GLASTAR SERVICE BULLETIN 16

Subject: Trim tab counterweight arm

Applicability: GlaStar Kits #5002–5249, inclusive

Figure 1: Finishing the New Counterweight Arm

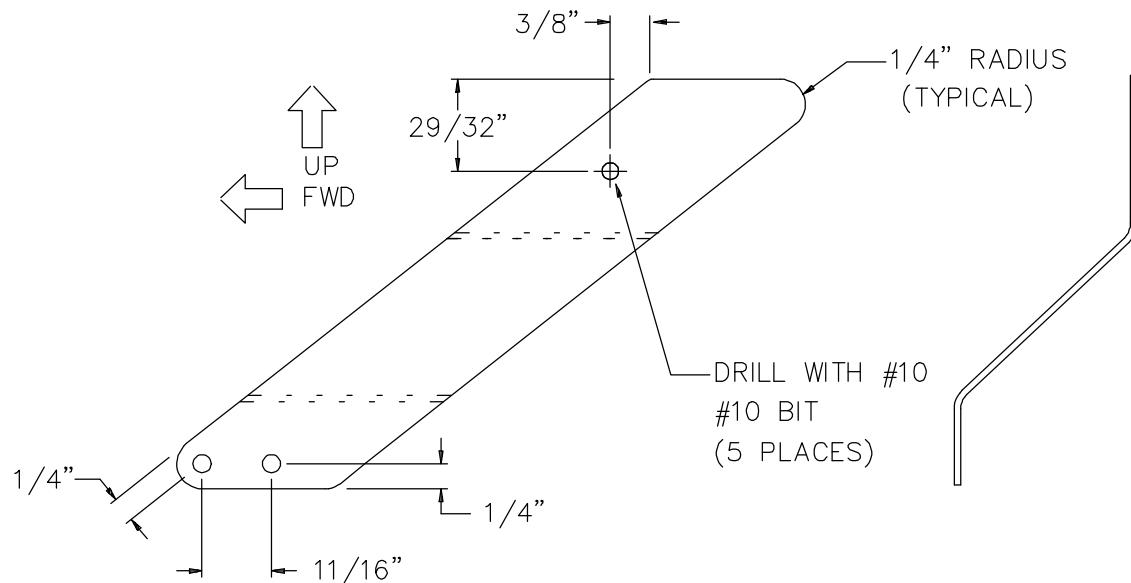
The new counterweight arm comes pre-bent, but you must drill holes for the pushrod and counterweight attach bolts, as well as radius the corners of the arm. Figure 1 shows the locations of the three #10 holes. Note that the **longer** of the two parallel faces of the arm is the **upper** one, and this is where the pushrod hole should be drilled.

Figure 2: Drilling the Counterweight Arm

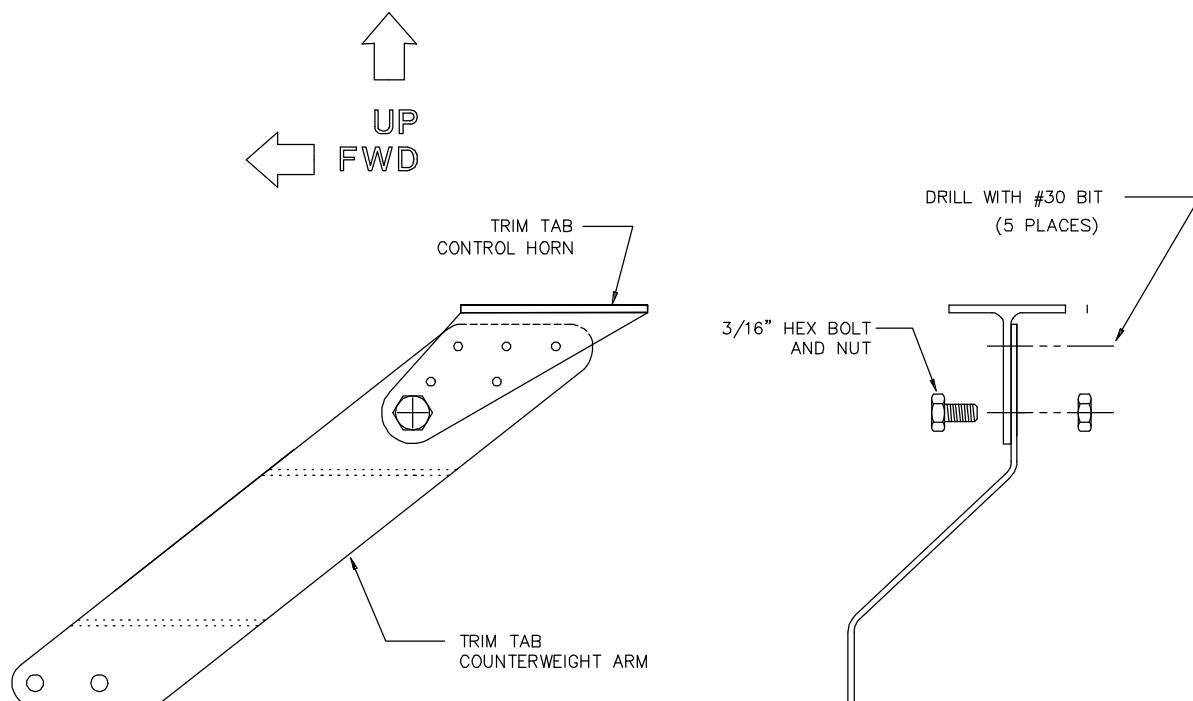
The next step is to use the five rivet holes in the control horn as guides to drill five matching holes in the counterweight arm. As shown in Figure 2, temporarily pin the arm to the horn with a hardware-store 3/16" bolt, aligning the upper edge of the arm with the horizontal flange of the horn, and drill the five holes with a #30 bit. (Note that these are larger holes than originally prescribed; you will be using 1/8" rivets to rivet the new arm to the horn.)

Figure 3: Riveting the Counterweight Arm to the Control Horn

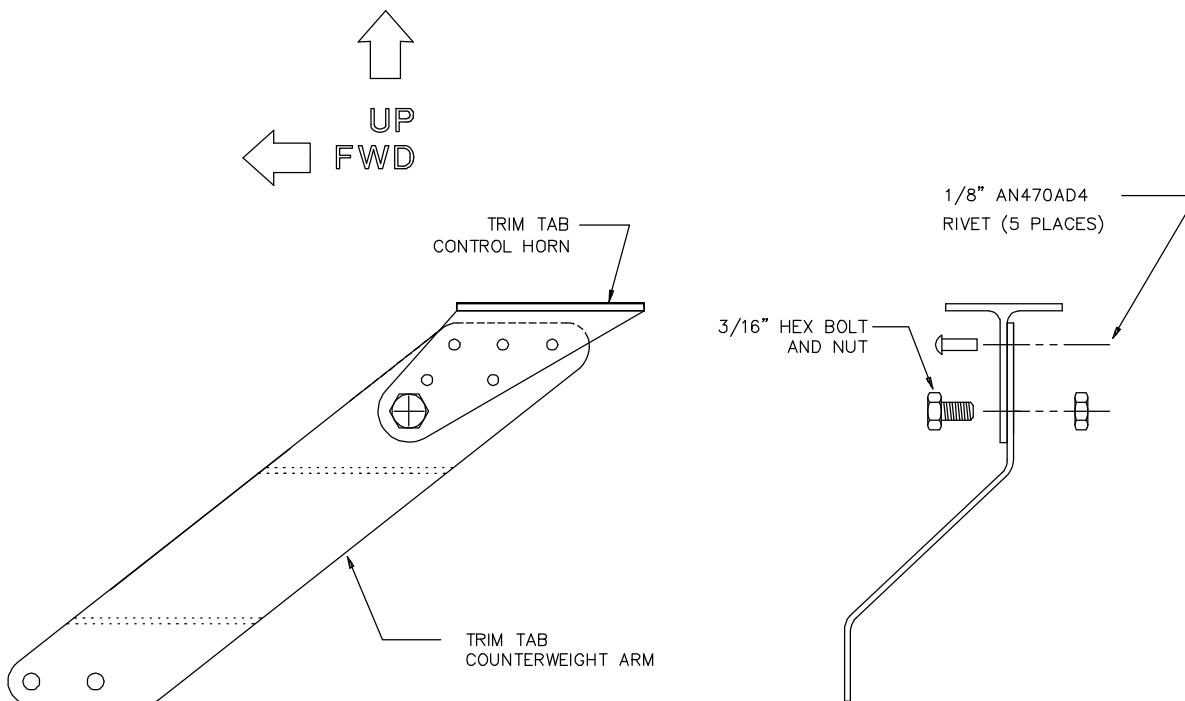
As shown in Figure 3, use 1/8" AN470AD4-5 universal-head rivets to rivet the counterweight arm to the horn. This procedure is identical to that in the *Assembly Manual*, "SECTION V: ELEVATOR ASSEMBLY," Step 72, except that you're using the new arm and larger rivets. Note that the arm should be on the **right-hand** side and the rivet heads on the **left-hand** side of the horn, relative to the aircraft. This is necessary for the trim tab pushrod to line up with the proper clearance on the left side of the horn.
